123 FERC ¶ 62,200  
UNITED STATES OF AMERICA  
FEDERAL ENERGY REGULATORY COMMISSION

Project No. 1904-051

ORDER APPROVING PLAN TO MONITOR EFFECTIVENESS OF UPSTREAM FISH  
PASSAGE PURSUANT TO REVISED ARTICLE 402

# Upstream Fish Passage Monitoring Plan

### **ILLUSTRATED FLOW SCENARIOS FROM CFD STUDY**

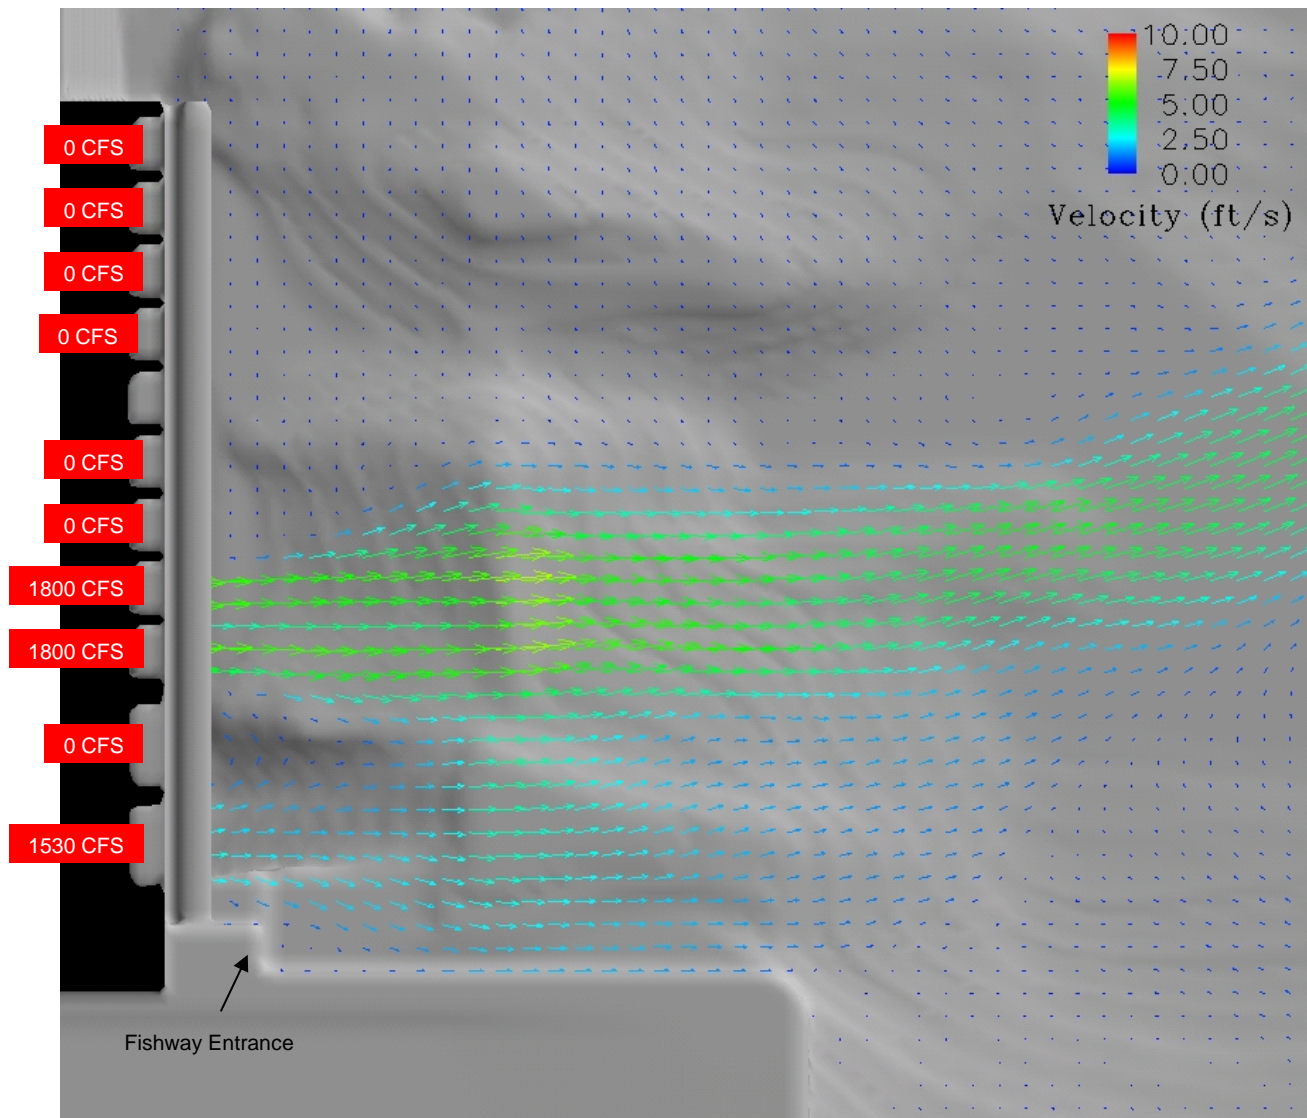
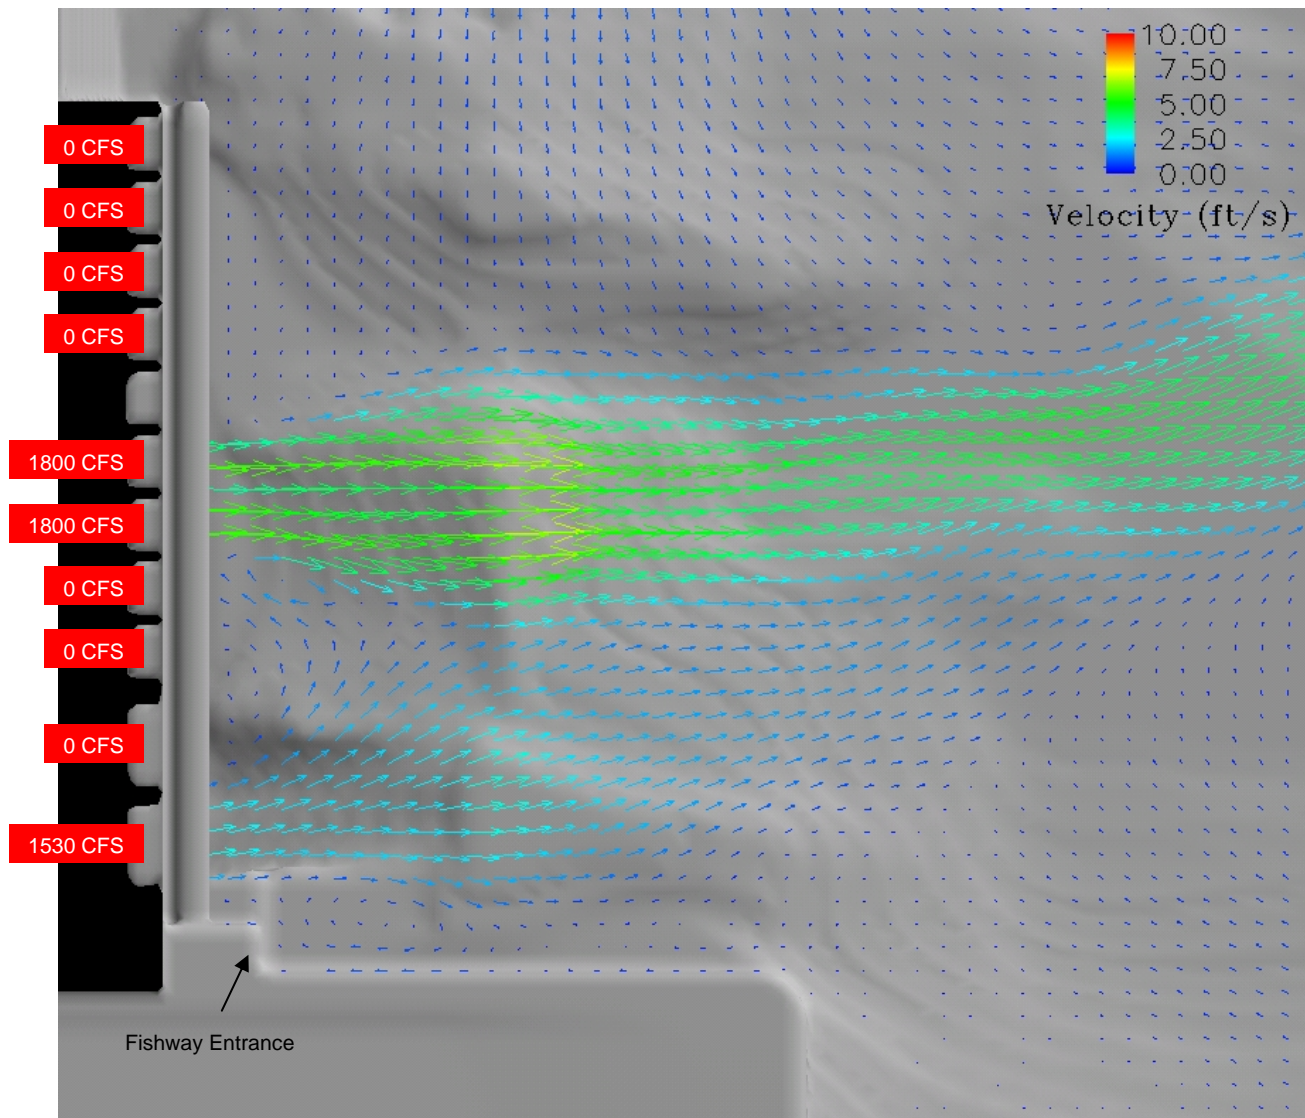
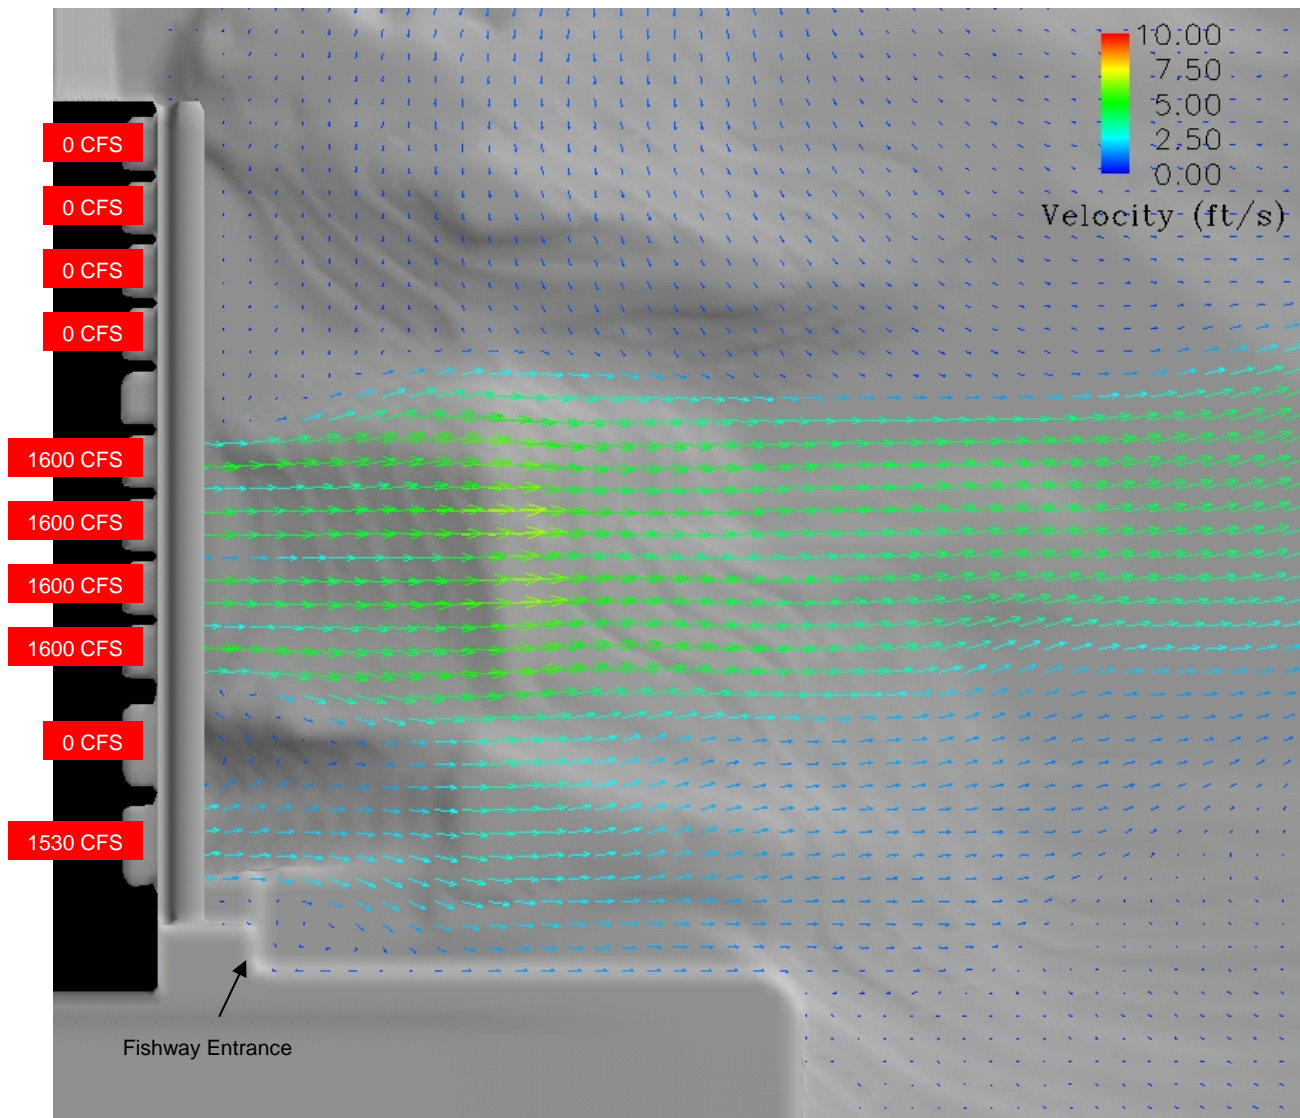
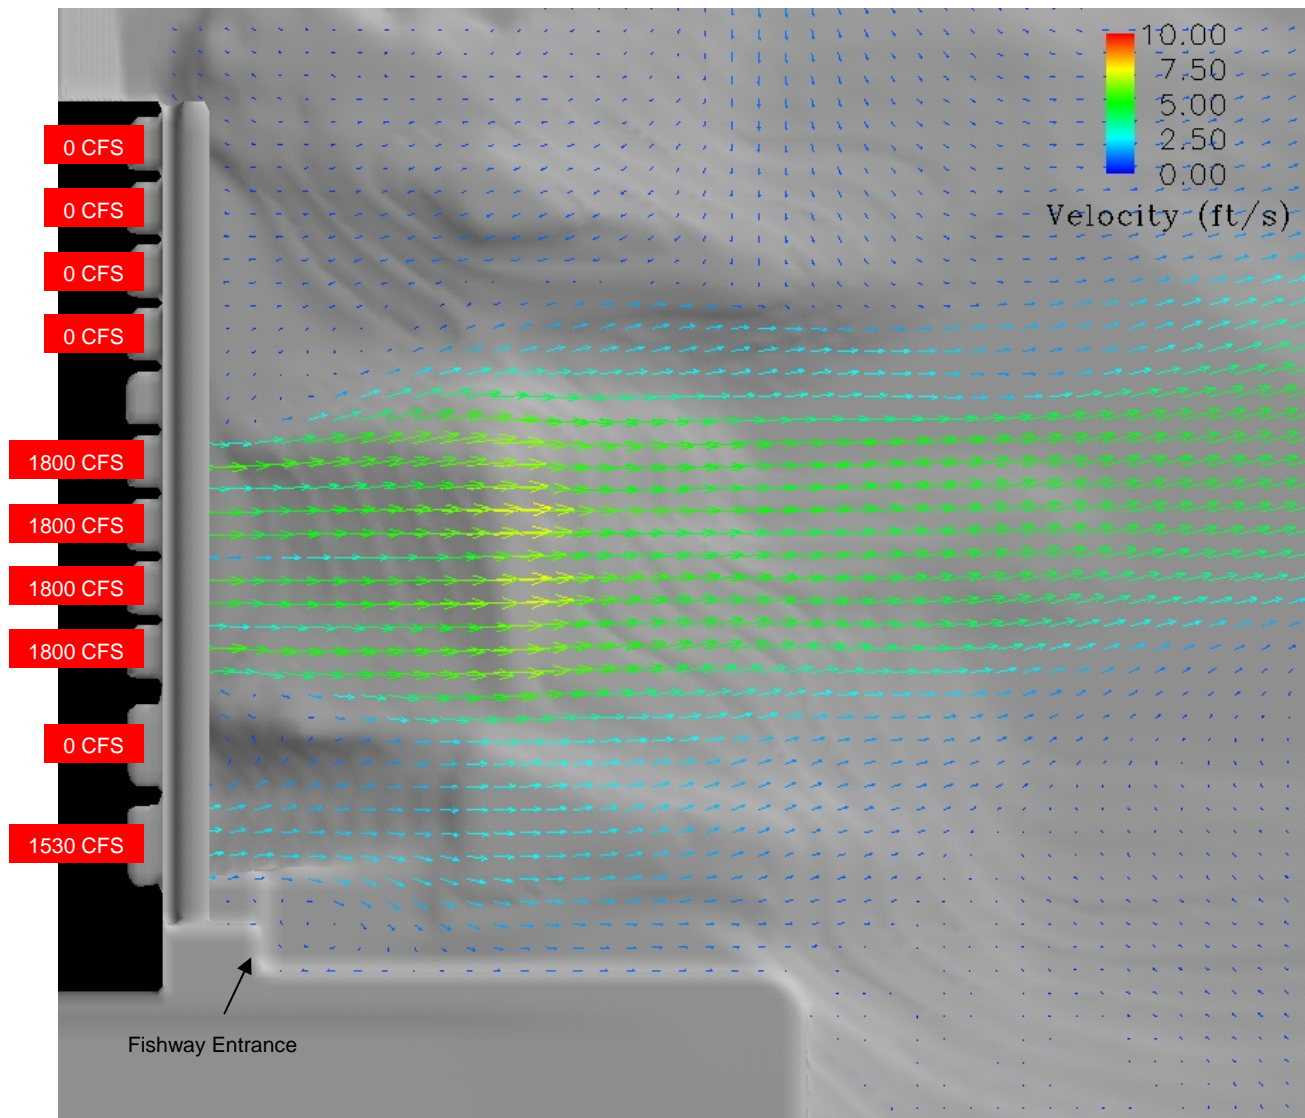
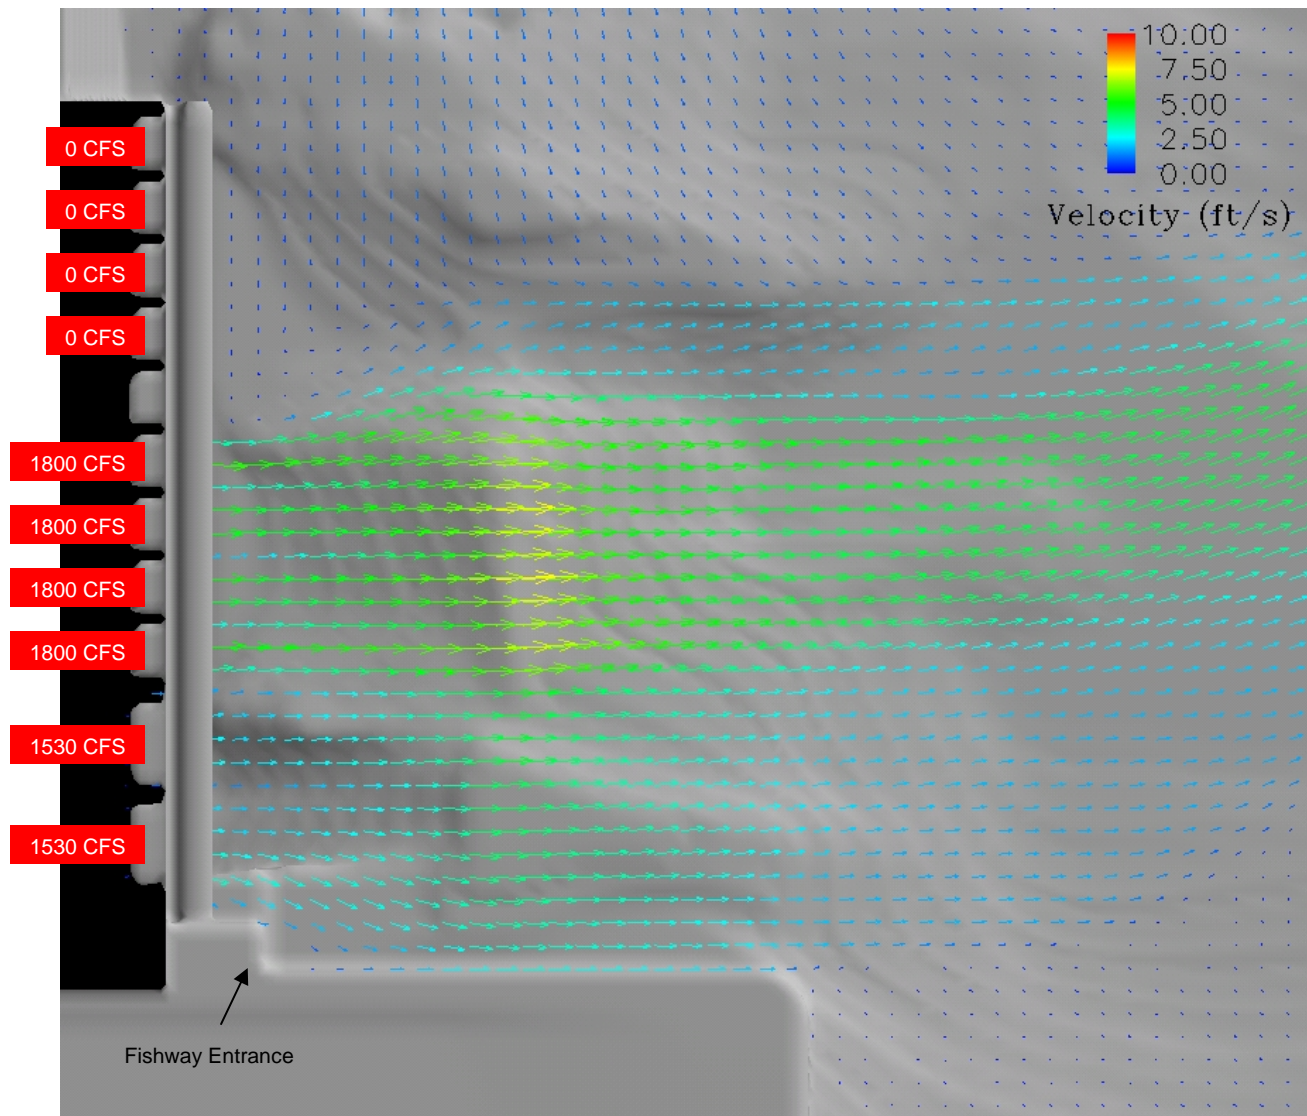
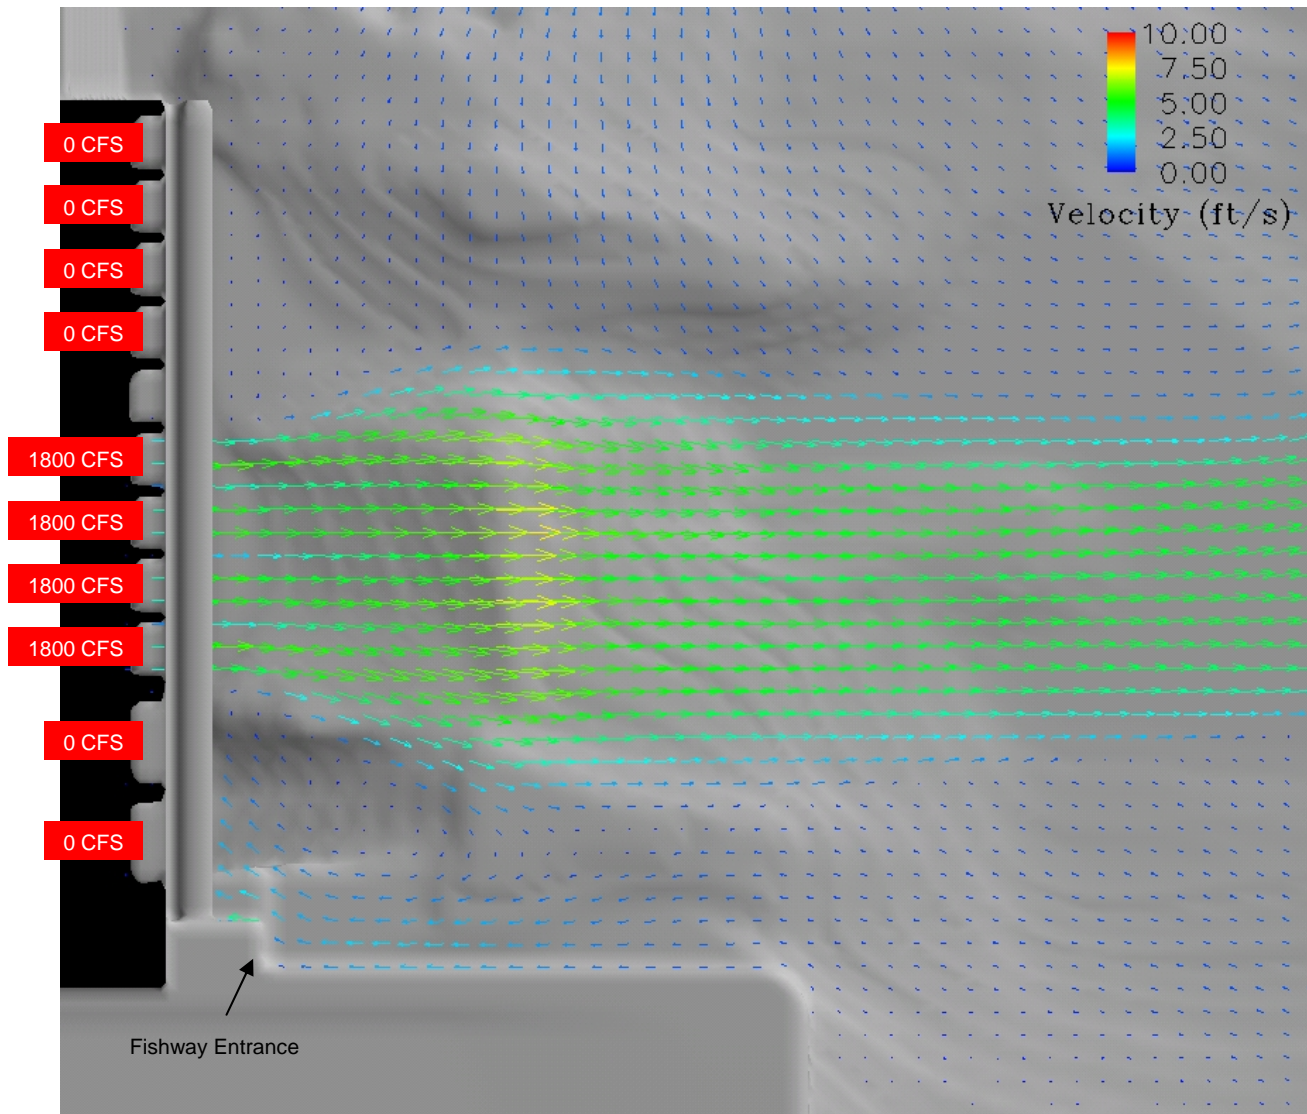
**Appendix A - Illustrated Flow Scenarios from 2005 Alden CFD Study** - The figures and flow vectors presented in the report are too small to be meaningful. Enlarged figures showing the fishway entrance should be included for each scenario. It is unclear from the figures if the CFD modeling runs included the normal 200 cfs discharge from fishway entrance, which should have been the case.

<p>USFWS_4: (Appendix A)</p> <p>The figures and flow vectors presented in the report are too small to be meaningful. Enlarged figures showing the fishway entrance should be included for each scenario. It is unclear from the figures if the CFD modeling runs included the normal 200 cfs discharge from fishway entrances, which should have been the case.</p>	<p>Figures included in Appendix A of the Final Plan have been enlarged for better readability.</p> <p>The CFD modeling runs did not account for the discharges from the fish ladder entrance and from the downstream passage West Fishtube. However, the CFD final report concluded that those attraction flows would tend to further decrease the potential for eddy formation when Unit 10 is operated first-on, last-off followed by Units 7 and 8, and then by Units 5 and 6. Section 3.3 of the Final Plan has been modified to</p>

include this conclusion from the CFD modeling study. The effects of attraction flows, if any, should be noted in the field evaluation.
<p>USFWS_5: (cover memo)</p> <p>Lastly, as noted in the cover memo, specifics regarding the field evaluation in spring 2008 are still to be developed. This should be discussed in the plan itself. We recommend that the Plan specifically state that the details of the field evaluation will be developed in consultation with the consulted agencies and that the Implementation Schedule, Table 2, include entries regarding when such discussions will occur and when the field evaluation details will be finalized.</p>	<p>Sections 4.1 – 4.3, 5.0 and Table 2 have been modified in the Final Plan to include additional detail about developing the specific field evaluation study to be conducted in spring 2008.</p>
